EnerTech Global, LLC 2506 S. Elm Street Greenville, IL 62246 <a href="http://www.enertechgeo.com">www.enertechgeo.com</a>	<b>TECHNICAL BULLETIN</b>	DOC. #:	QMS-TSF-001
	<b>Control Board Resistor Failure (47P001-01NN)</b>	TEMPLATE REV DATE:	05/19/2016
		TB #:	17.002
		PUBLISH DATE:	11/2/2017

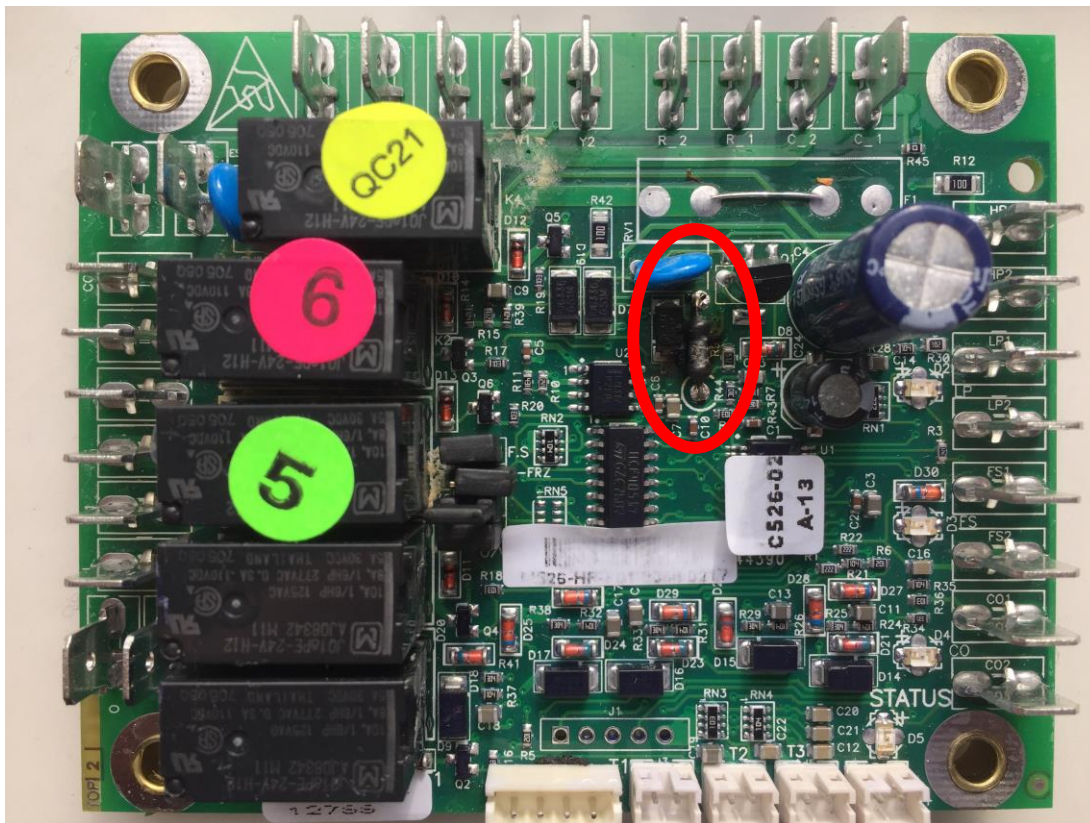
A series of failed control boards has led to EnerTech discovering bad components on the control board 47P001-01NN. When these boards fail, a resistor can be seen that is burned (see image below). This results in a dead board. The defective boards have been traced back to a single supplier that was used in all VS/VT and YT units manufactured between February of 2017 to October 2017. The suspect serial range includes M1702XXXX – M1710XXXX.

Identifying boards:

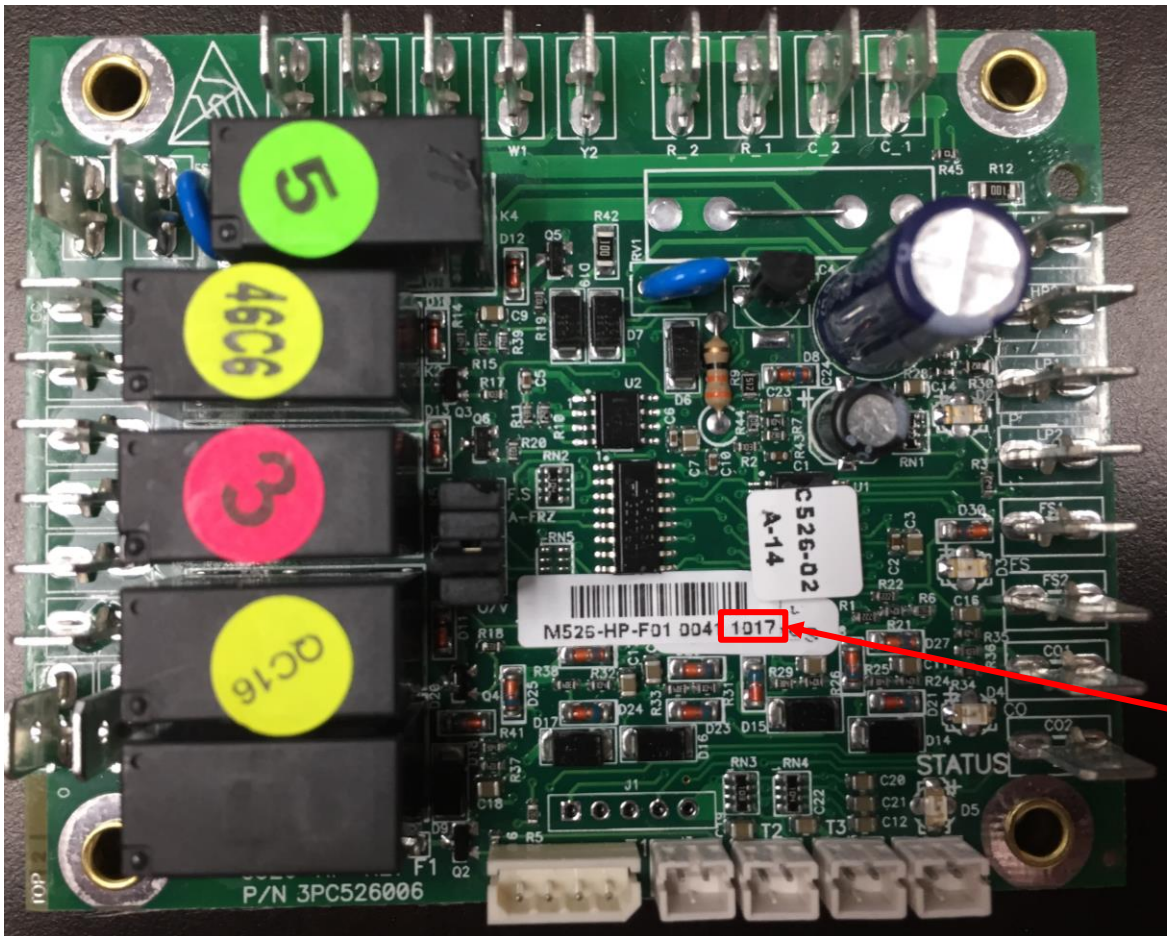
Units within the cited date range and serial number should have the control board checked:

Affected date codes include:  
 "0217", "0317",  
 and "1017"

If the date code on your board is not listed, **no action is required**. If it is one of these date codes, continue through the end of this document.

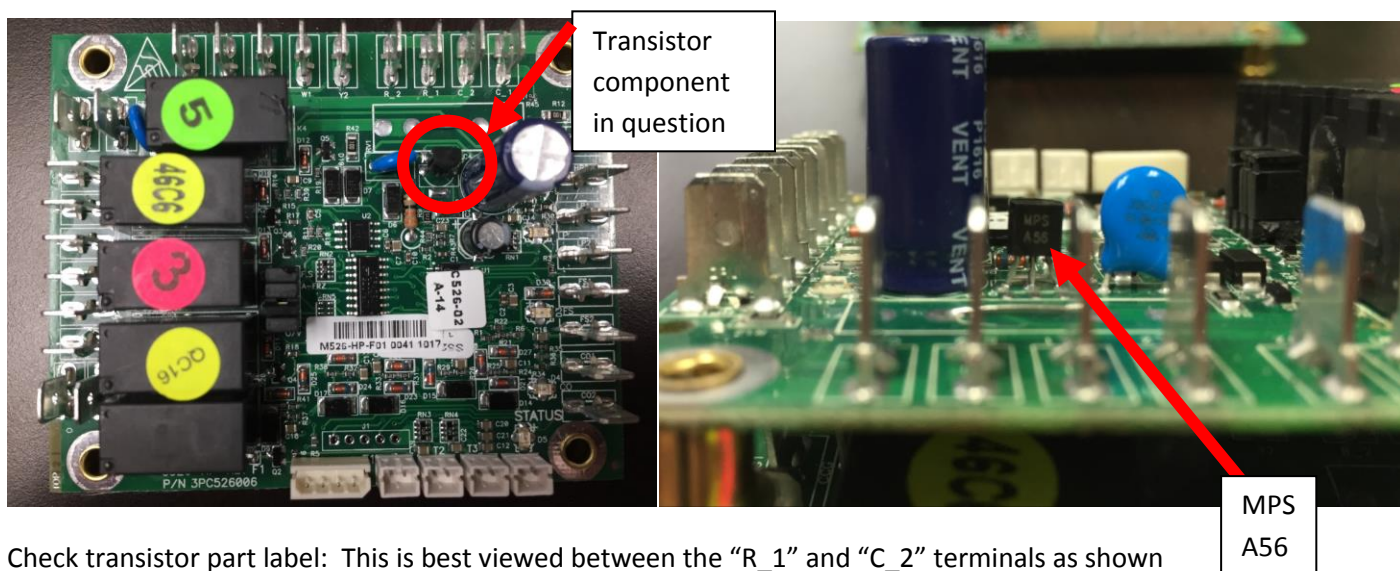
Check Transistor: If a board is found with one of the above date codes, check for the bad component

Check transistor part label: This is best viewed between the “R\_1” and “C\_2” terminals as shown

If it is labeled “MPS A56” it is a **BAD BOARD. Replace immediately.** The control board should be replaced with the same part number **47P001-01NN**.

The correct component should read “MPS A06”. If that is the component found, no action is required.
